Re: Summary of Amendment to Minor Change Application for K205BJ, Bend, OR
BPFT-20031124ALW
State of Oregon Acting By and Through the State Board of Higher Education (“Applicant”)

Ref: BPFT20031124ALW
Relocating of FM Translator K205BJ

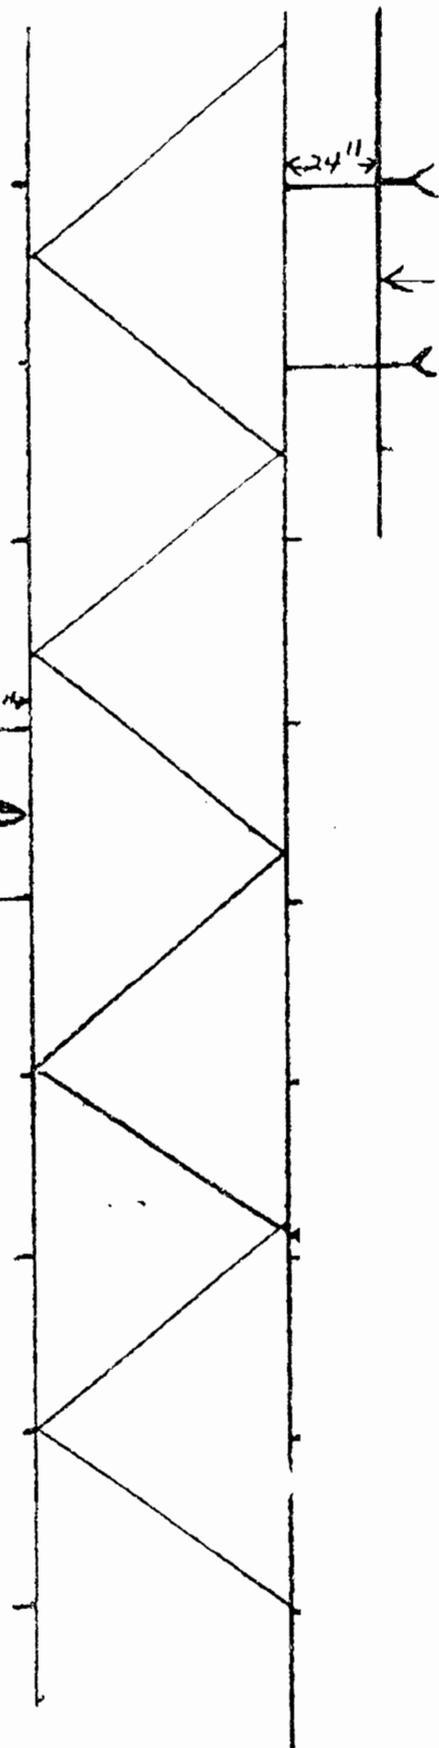
In response to your email of 12/01/03 regarding potential disruption to the pattern of K285DH, the Applicant will be amending its above-referenced pending application, to specify a higher antenna height on the tower. Attached is a tower sketch of this plan. Based on this, and our assurances that any coaxes would be closely attached to tower legs, Kathrein/Scala Sales Engineer Mike Johnson issued the attached letter indicating that K205BJ should have “no anticipated significant adverse affect” on the pattern of K285DH.

Here are the numbers in detail: The Applicant’s pending application for K205BJ calls for a Shively 6812, 2 bay, half-wavelength omni-directional antenna mounted at 11 meters (36 feet) AGL. We are amending this to be 14.47 meters (47.5ft) AGL. With rounding, the amendment will specify 14m AGL. This would put the two bays at 13.6m and 15.3m AGL.

Meanwhile, K285DH currently operates with a Scala CA-2 2-bay directional antenna (one horizontal bay, one vertical bay). Their licensed antenna height is 10m AGL. K285DH also has a CP to install a Scala CA-2 (horizontal-only) 2 bay directional antenna at 10m AGL. The actual center of radiation, without rounding, will be 9.9m (32.5ft) AGL. The two CA-2 bays will be half-wavelength spaced, which will put them at 9.2m and 10.6m AGL.

Therefore, the uppermost bay of K285DH would be 3.0 meters below the lowermost bay of K205BJ, as amended. Scala’s standard is that its directional antennas should have one-wavelength clearance vertically from other antennas. On channel 285, one-wavelength is 2.85m. The 4.6m separation mentioned in Mr. Johnson’s letter is a center-to-center (of radiation) distance.

With the proposed vertical spacing of 4.6 meters (greater than 1 wavelength of the K285DH 104.9 Frequency), there is no anticipated significant adverse effect to the directional radiation pattern of station K285DH from the relocating of the K205BJ Non-Directional antenna or the routing of the transmission line.
